Application No. 09/663,469

APPENDIX TO AMENDMENT OF AUGUST 1, 2002

Fig. 2

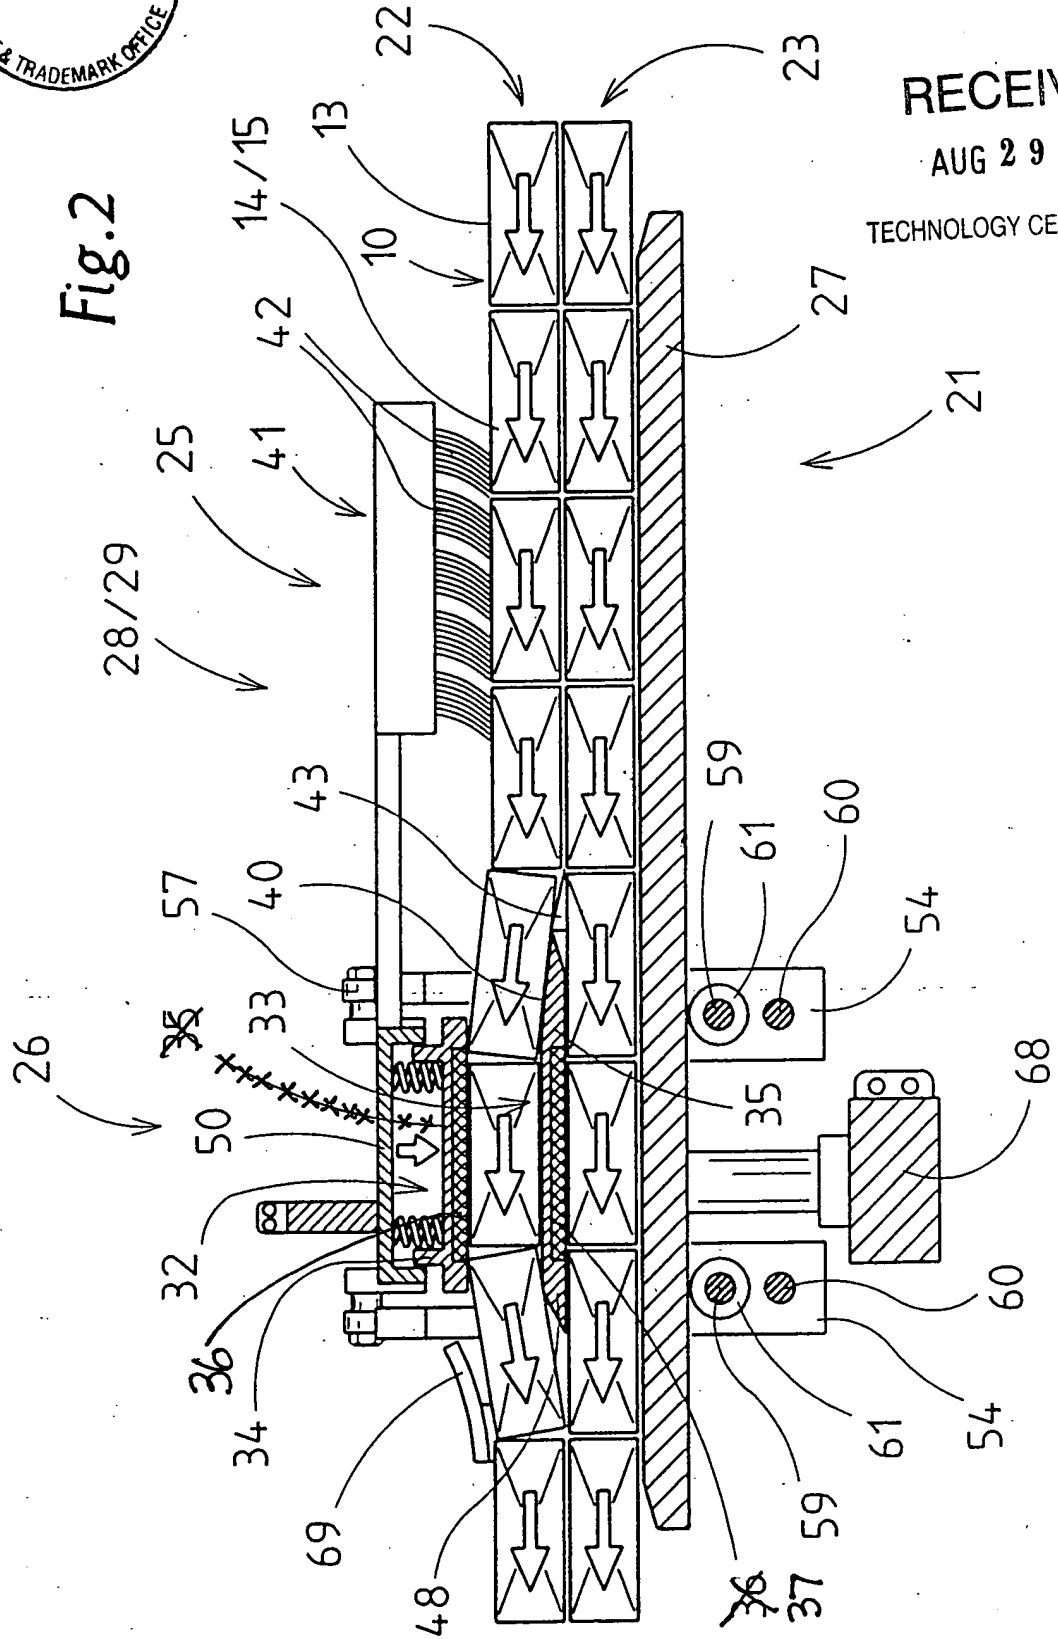
The drawings were objected to on several grounds. The objections are addressed in the enclosed Request for Approval of Drawing Corrections.

ACCEPTED 9/19/02
